RE: The Hut, 305 N 4th Ave, 305 N Herbert Ave, 321, 323 & 327 E 8th Street
T20SA00218. IID-19-15

*I have reviewed the submittal for **The Hut, 305 N 4th Ave, 305 N Herbert Ave, 321, 323 & 327 E 8th Street T20SA00218. IID-19-15** submitted July 29, 2020, for compliance with the UDC Infill Incentive District (IID), UDC Section 5.12.2, 5.12.8, and 5.12.10. My comments have been prepared in advance of an Infill Incentive District Design Review Committee meeting, scheduled for _____, 3rd Floor Large Conference Room, Planning & Development Services, 201 N. Stone Avenue; Tucson, AZ.*

This review is the second time I have reviewed elements of this proposal and the first formal review of a complete package prior to its review by the Design Review Committee of the IID. I was unable to attend the Pre-Application meeting of December 12, 2019, but my comments in black were provided to the City of Tucson and the applicant prior to that meeting.

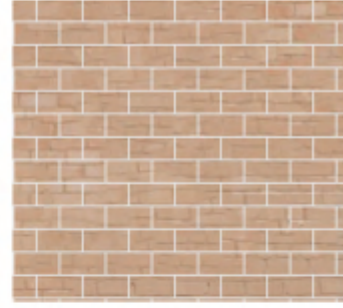
It is the opinion of the Design Professional that the proposed design for the landscape and the storage structure complements and is compatible with the Contributing Structures on the Hut site. It does not imitate the design but respectfully builds a contemporary structure that achieves compatibility as described above in item (2). The proposed building materials and landscape materials do an excellent job of integrating with this 4th Avenue Historic Commercial District.

Rusted Metal

Existing Brick

New Integral Color Block

Fabric Awning

Thornless Texas Honey Mesquite

Slipper Plant
